City of Evansville **Plan Commission**
Regular Meeting
City Hall, 31 S Madison St., Evansville, WI 53536
Tuesday, October 7th, 2025, 6:00 pm

Date: Tuesday, October 7, 2025
To: Plan Commission
From: Colette Spranger, Community Development Director
Re: Status of Site Plan for Culvers, 60 N. Union Street

SITE PLAN APPLICATION – STAFF REPORT

Applications: SP-2025-01, RZ-2025-05

Rendering depicting masonry wall above grade.

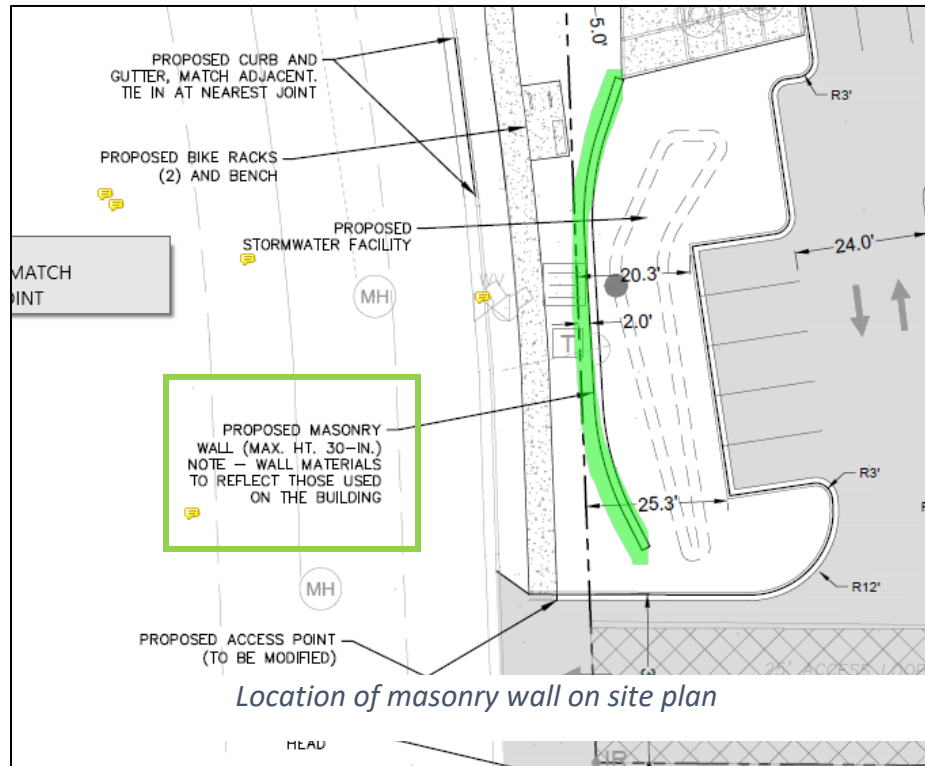
Construction for the new Culver's Restaurant culminated at the end of July. Staff completed a site inspection, checking the submitted and approved site plan for completion. One of the items needing to be addressed is the masonry wall shielding the parking lot from view along Union Street. This is a requirement of the B-3 zoning district, which states that no more than 50% of the frontage along the street should be park of the parking lot. The City has mandated this for other new builds along Union Street in past year, including the Night Owl and Dollar General, both of which amended their site plans to accommodate this requirement. The masonry wall along Union Street was to be Culver's way of meeting that requirement. On the site plan, a 30" masonry wall was depicted, described as using materials similar to the ones on the building.

Upon further inspection of the site with the general contractor, it was explained that the wall was installed correctly per the building and grading plans – most of the 30" is below grade and acts as a retaining feature of the stormwater pond. This was not apparent in the site plan materials submitted.

The result is a parking lot that is not shielded from view along Union Street. While the vegetation surrounded the wall may grow and thicken, adding to the street wall appearance, it does not achieve the same effect as a masonry wall. (For reference's sake, Incridiball Smooth Hydrangea has a size a full growth of 4-5 feet and grows behind the wall closer to the parking lot. Tara Prairie Dropseed grows 2-3 feet at full height and is located between the wall and public sidewalk. Full growth assumes proper care, which can be difficult in a parking lot setting if landscaping is not maintained.)

In the close out letter sent to the property owner, staff requested that a masonry wall of 24" at grade be built by November 30th of this year. The owner is requesting a reprieve from building the remainder of wall, citing concerns for safety of pedestrians if the wall is made taller. If 24" of stone is added on top of the existing wall, there will be a drop of 2.5 feet from the top of the wall to the embankment of the stormwater pond.

Plan Commission approved the site plan and has the authority to review modifications to the site plan, including those that "would materially change the appearance of a building or other structure." (Section 130-206 of the Zoning Code.) For this reason, staff is deferring to Plan Commission for a final decision: should the masonry wall be built as requested to 24" above grade or can the wall remain as-is? Plan Commission is welcome to discuss another option that achieves the goal of providing a street wall/shielded parking lot design as outlined in the Allen Creek Corridor Plan.

Aerial view showing informal parking spaces over public and private land.

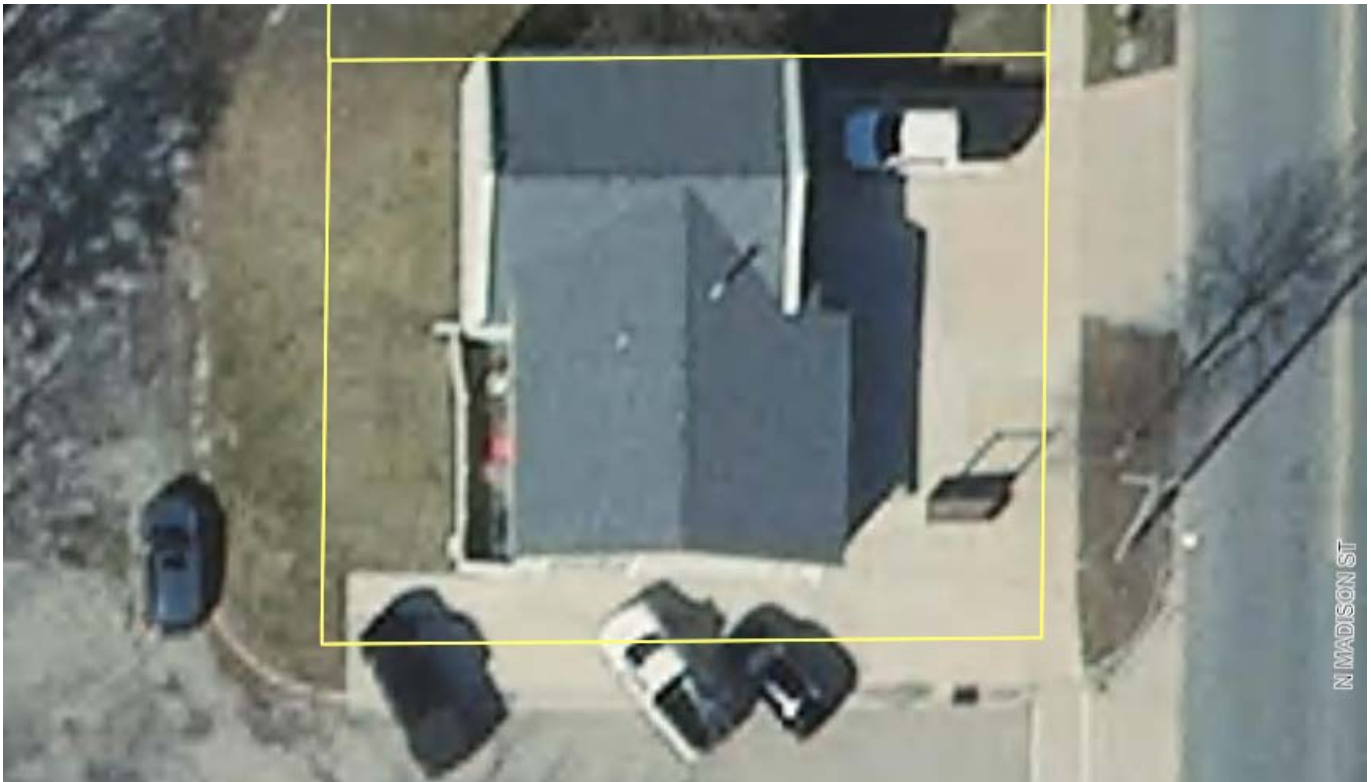
The applicant has suggested striping angled parking along the south side of the building along Park Drive. This area has long been in use as an informal parking lot (since at least 2007, likely earlier) but is technically within the City right-of-way. Striping parking spaces of appropriate size would also extend those spaces into Park Drive by about 15 feet. When building improvements were done to the interior of this building in 2018, a discussion occurred regarding the future of this encroachment. At the time, it was agreed that the parking could remain until Park Drive is either reconstructed or resurfaced. Preliminary planning by the City suggests this might occur in 2028 or along with reconstruction of Madison Street, which the Department of Transportation plans for 2028/2029.

At this time, the missing curb along Park Drive will be rebuilt. The property owner would then be responsible for adding a sidewalk at the property line going around the south and west sides of the lot. The City can then stripe parallel parking on Park Drive adjacent to the new curb and potentially add angled parking on the west side of the property. This would clean up the look of the area and correct a long-time encroachment onto Park Drive.

- 1. Common Council approves Ordinance 2025-11.***
- 2. Parking area on south side of property encroaching into Park Drive is allowed to remain until the City reconstructs or repaves Park Drive.***
- 3. If striping is desired in the area described above in item 2, applicant will notify and work with City Public Works Department. Striping will be performed by City staff.***
- 4. After reconstruction or repavement of Park Drive, the City will require the applicant to install a sidewalk on the south and west sides of the property along Park Drive.***
- 5. Any major deviations from approved plans will require a resubmittal of application and possibly fees or enforcement action.***
- 6. Applicant records the site plan with the Rock County Register of Deeds.***

LICENSE NUMBER:	-
NEW HOME PLANS FOR:	BERG OFFICE ADDITION 129 NORTH MADISON ST. EVANSVILLE, WI. 53536 CELL PHONE: 608-212-3703
PAGE TITLE:	SITE PLAN
DRAWN BY:	JMH
DATE:	10/1/2025
SCALE:	1"=10'
SHEET #:	A2

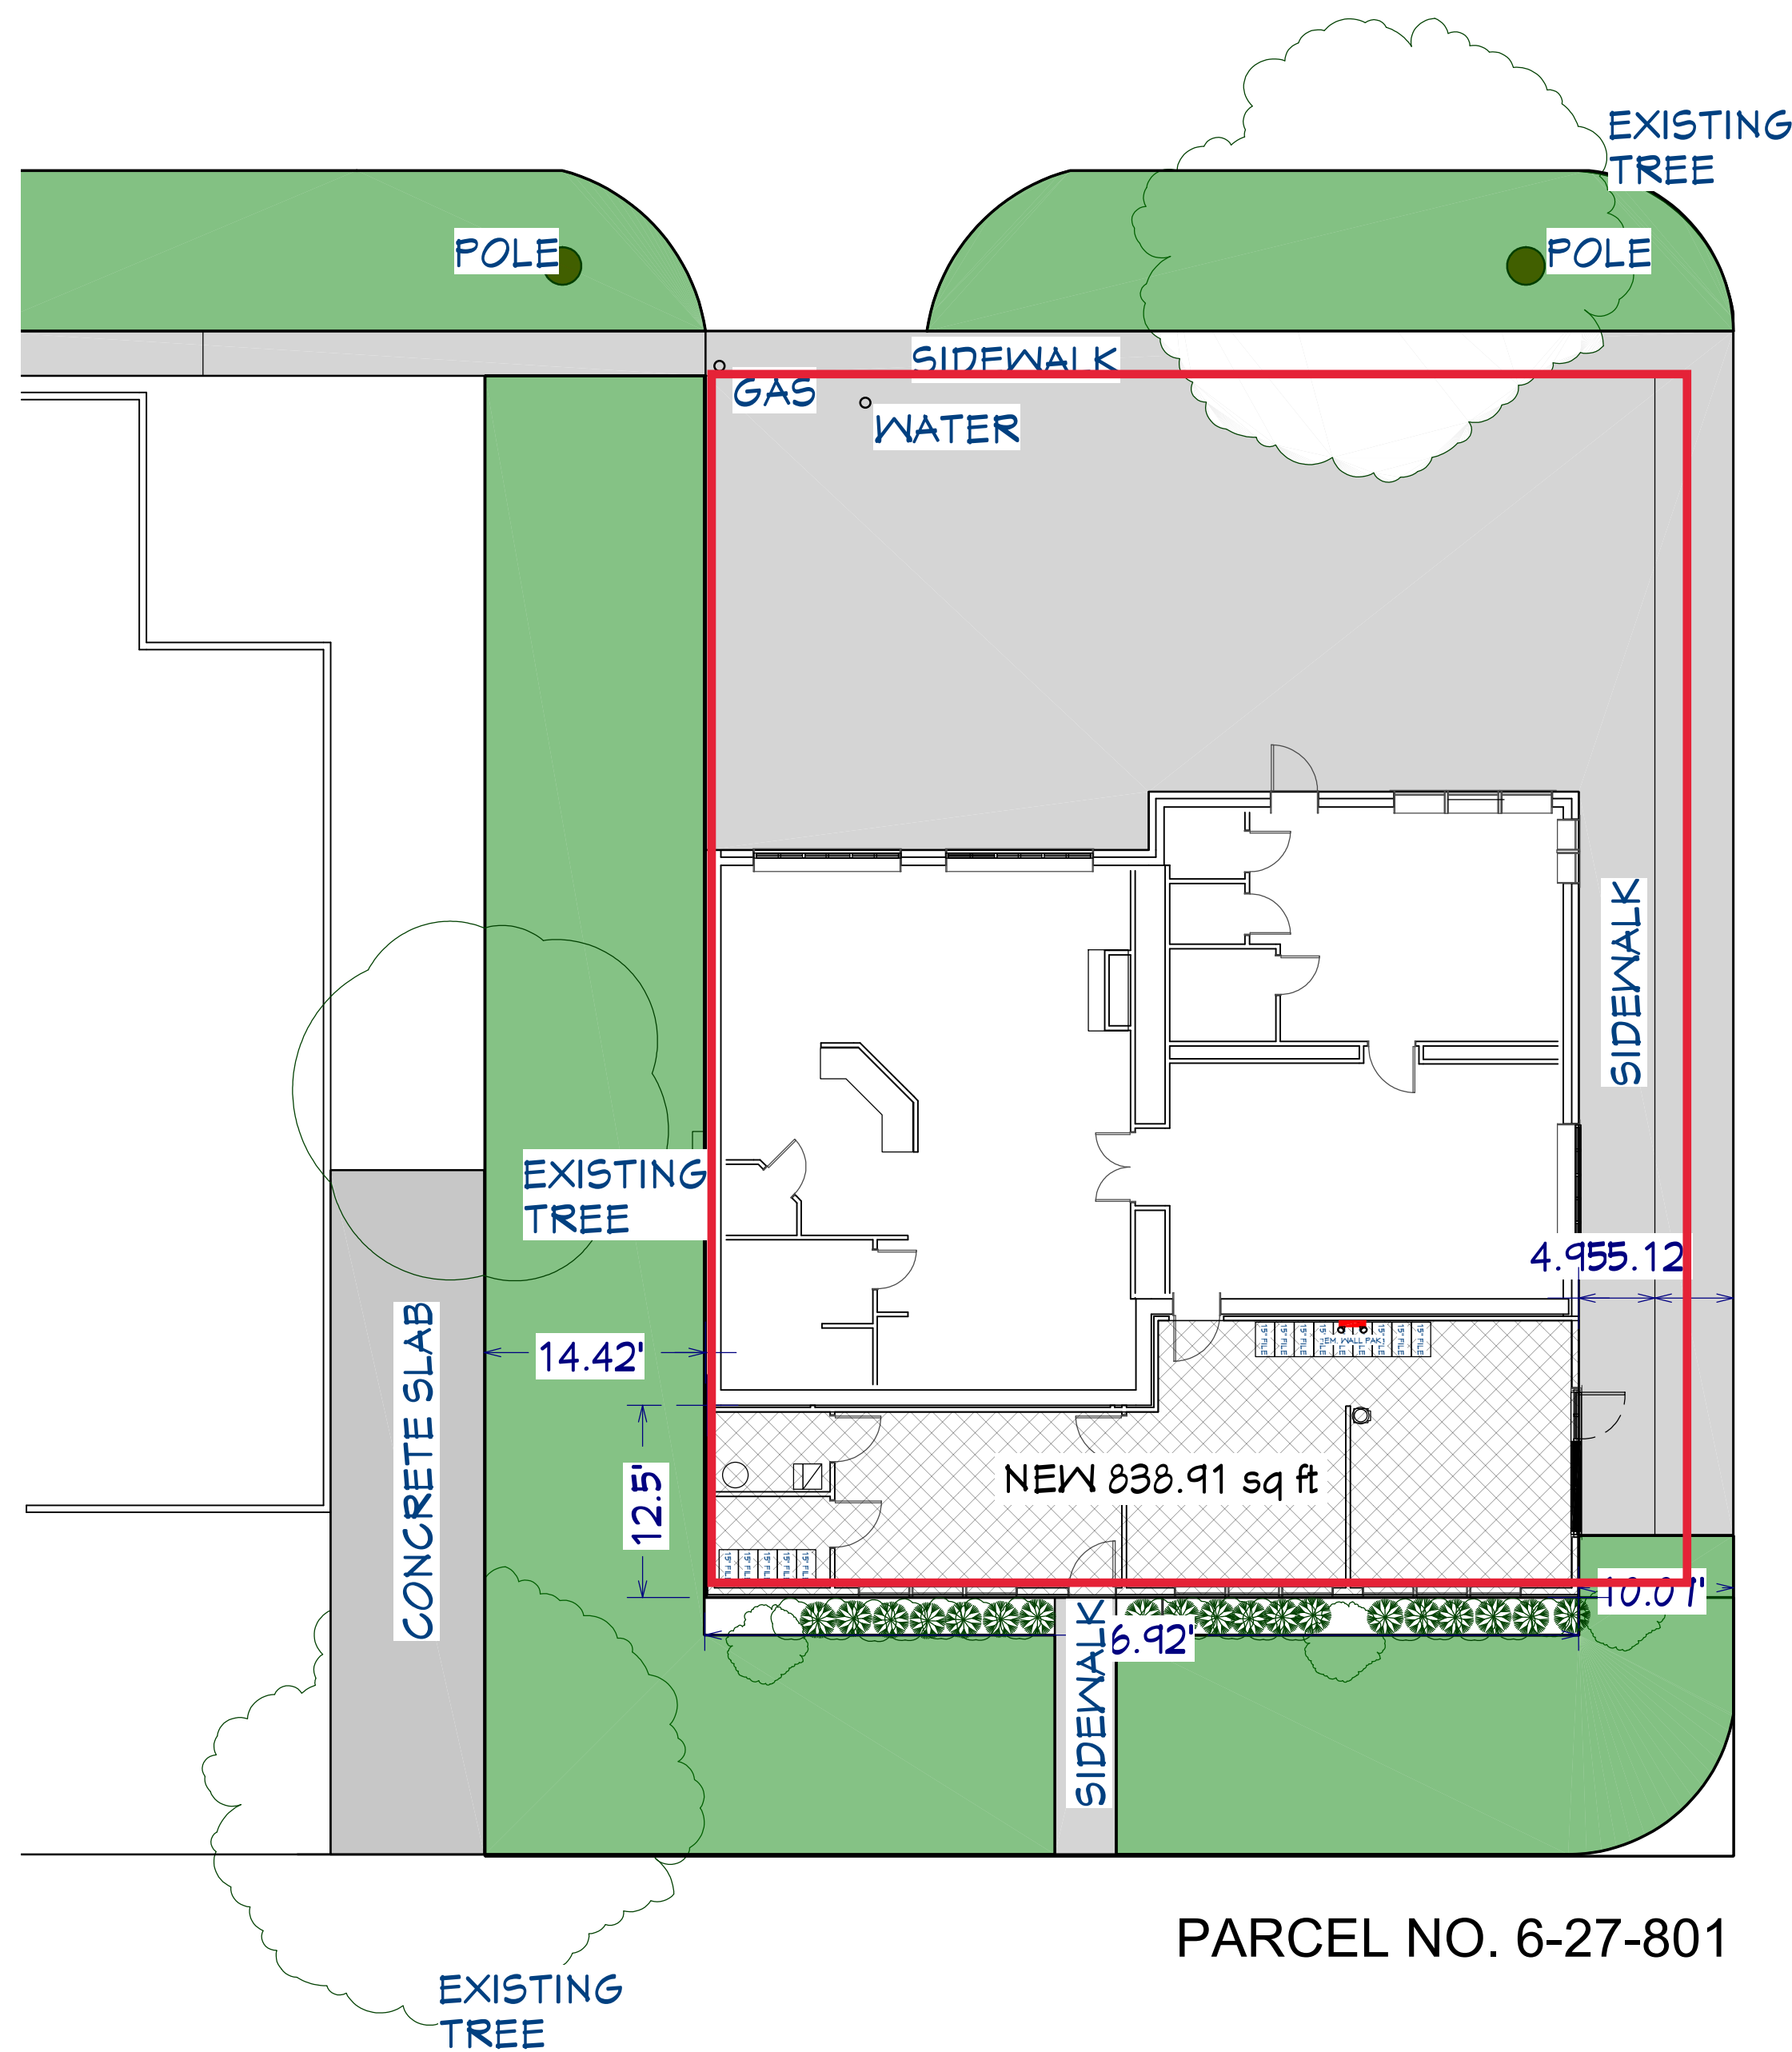
The expansion of the building itself is simple enough; the rear of the building will go to the lot line on side that abuts Park Drive. There is still 15 feet of right-of-way between the lot line and the curb for Park Drive, leaving ample space for an eventual sidewalk or potential utility needs. The siding, roofing, windows, trim, and other architectural details of the addition will match or compliment the existing structure. The building addition has a different roofline than the rest of the building but is otherwise complimentary in terms of size and massing.

2. Site location relative to public road network	<ul style="list-style-type: none"> Site is a corner lot with public streets on three sides. Recommendation to restore curbing on south end of lot and restore grass in the right-of-way, eliminating ambiguous ownership/maintenance of paved areas within and on Park Drive

4. Traffic Generation	<ul style="list-style-type: none"> Additional trip generation associated with the building addition is insignificant in the context of Madison Street, which is an arterial corridor through the City Cleaning up curb on south side will better direct traffic and cut down on potential vehicle conflicts at the Park Drive and Madison Street intersection.
